# Stage 05: Draft Final Modification Report

# GC0100 EU Connection Codes GB Implementation – Mod 1

**Published on:** 6 February 2018

Figure 3.15(a) – GB Proposed Voltage Against Time Curve of a Type B Synchronous Power Generating Module showing the conflict with Stage 2 G59 Undervoltage Protection

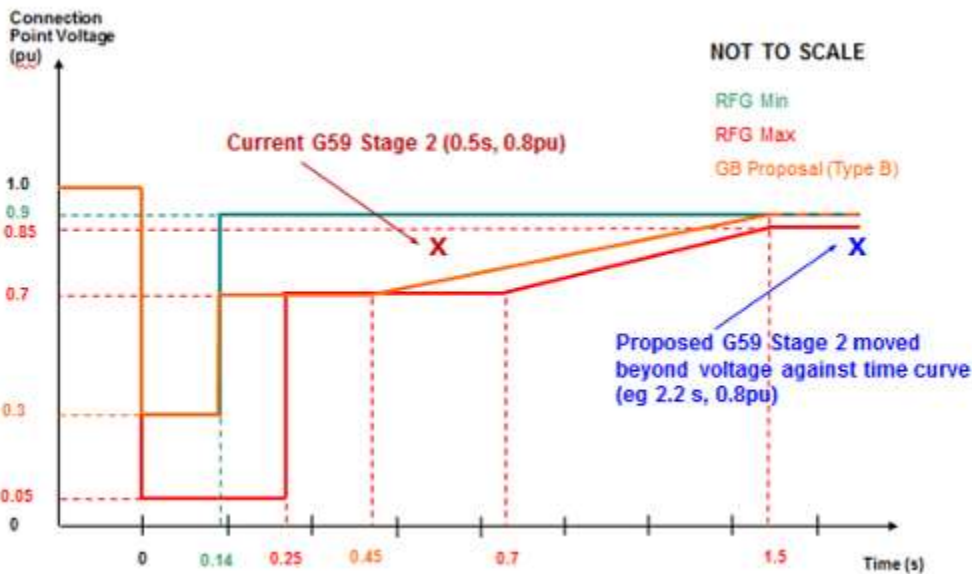
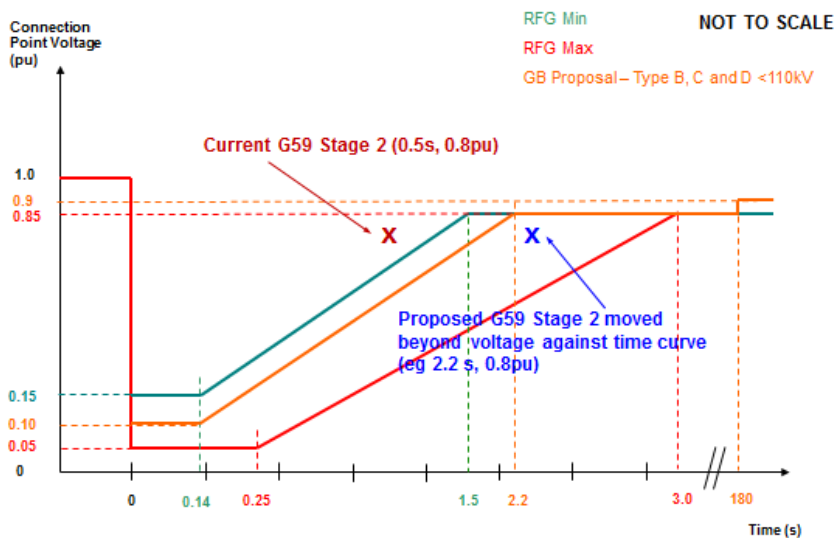
The Workgroup discussed this and The Proposer decided that the best policy for their original solution would be to move the G59 Stage 2 undervoltage protection to 0.8pu at 2.5s. This requirement would apply to all new connecting plant and would be equally applicable to Synchronous Power Generating Modules and Power Park Modules.

It was not believed that changing the G59 Stage 2 Undervoltage protection would cause a significant problem however it was included as a consultation question. The Grid Code/Distribution Code workgroups GC0035 and GC0079 continue to investigate the issues associated with changing RoCoF protection settings for distribution connected generators and have undertaken a risk assessment of Distribution system protection requirements. The analysis for this has been performed by the University of Strathclyde.

The University of Strathclyde were asked to comment on whether the proposed change to a single undervoltage protection would introduce any new risks. Their analysis pointed out that as the RfG only applies to new installations, it does not affect the risk profile for existing plant.

Figure ECC.6.3.15.4 - Voltage against time curve applicable to **Type D Sync**

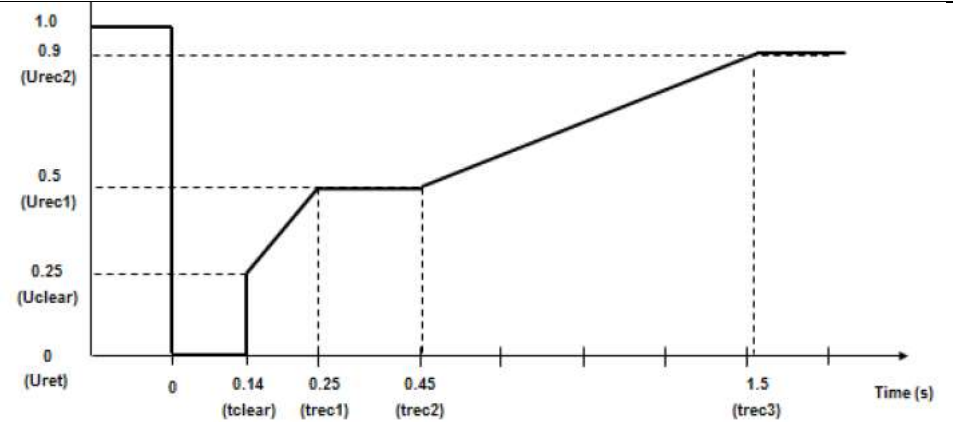
It is our understanding that the bold line in Figure ECC.6.3.15.4 shows the definite voltage profile at a Grid Entry Point for the time range 0-140ms; the profile after 140ms has a different meaning, namely a grid response to a fault which the plant should withstand. This is supported by Figure EA.4.2(a). Would it be more profitable to mark the definite voltage profile and the limiting grid response components in a different way for easier understanding.
